Service Bulletin

No. : MZ09-153

Model: SR8002, SR7002

Subject: Change in the "UL mark" on the rear panel because the expiration date of the "safe standard of Canada (CSA)" expired.

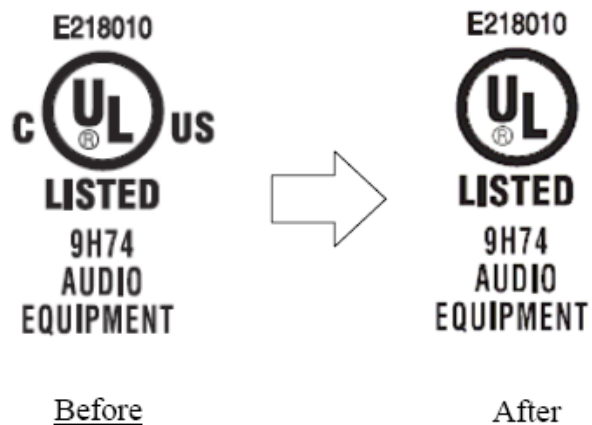
Details: The listed models were authorized under "UL1492" and "CSA22.2 No. 1-04". However, the expiration date of "CSA22.2 No. 1-04" expired at 31st of December 2009. Therefore, we changed the "UL mark" on the rear panel from "a mark for both of UL and CSA" to "a new mark for UL only".

We will apply the above modification to models in the following serial numbers.

Model	Serial Number
SR8002	MZ111004005351 ~
SR7002	MZ111002009691 ~
